Access Compliance Report

Public Rights-of-Way

(Curb Ramps)

Intersection ID: 42580	Main Street: GERALDINE_POWE_DR	Cross Street: RISING_OAK_DR	Location: NW
ADA ID: A1ABCA2C4075	Ramp Type: PerpDiag	Initial Pass/Fail: Fail	Overall Compliance: No
		Severity Score: 10

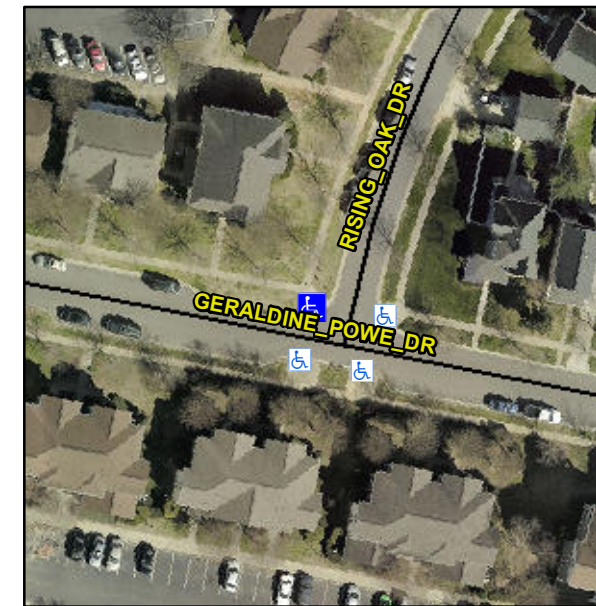
Not Found, R304.5.1, R304.5.3

Compliance	Description	Data	Compliance	Description	Data
N/A	Ramp Length (in)	146.0	Yes	Ramp Slope (%)	5.7
No	Ramp Width (in)	47.0	No	Ramp XSlope (%)	4.0
N/A	Flare Type LT	N/A	N/A	Flare Type RT	N/A
N/A	Flare Slope LT (%)	N/A	N/A	Flare Slope RT (%)	N/A
N/A	Flare Traversable LT?	N/A	N/A	Flare Traversable RT?	N/A
N/A	Landing Length (in)	N/A	N/A	DWS Provided?	N/A
N/A	Landing Width (in)	N/A	N/A	DWS Contrast?	N/A
N/A	Landing Slope (%)	N/A	N/A	DWS Length (in)	N/A
N/A	Landing X Slope (%)	N/A	N/A	DWS Full Width?	N/A
N/A	Landing Curb? (Y/N)	N/A	N/A	DWS Offset (in)	N/A
N/A	Shared Landing?	N/A			
N/A	Gutter Ponding?	N/A	N/A	Gutter Slope (%)	N/A
N/A	Gutter Lip Ht (in)	N/A	N/A	Gutter X Slope (%)	N/A
N/A	Painted X Walk1?	No	N/A	Painted X Walk2?	No
	X Walk 1 Direction	To S		X Walk 2 Direction	To SE
N/A	X Walk 1 Width (in)	N/A	N/A	X Walk 2 Width (in)	N/A
	X Walk 1 Slope (%)	2.8		X Walk 2 Slope (%)	0.6
	X Walk 1 X Slope (%)	0.7		X Walk 2 X Slope (%)	3.4

Remove & Replace Curb Ramp With Two New Directional Ramps or Equivalent.
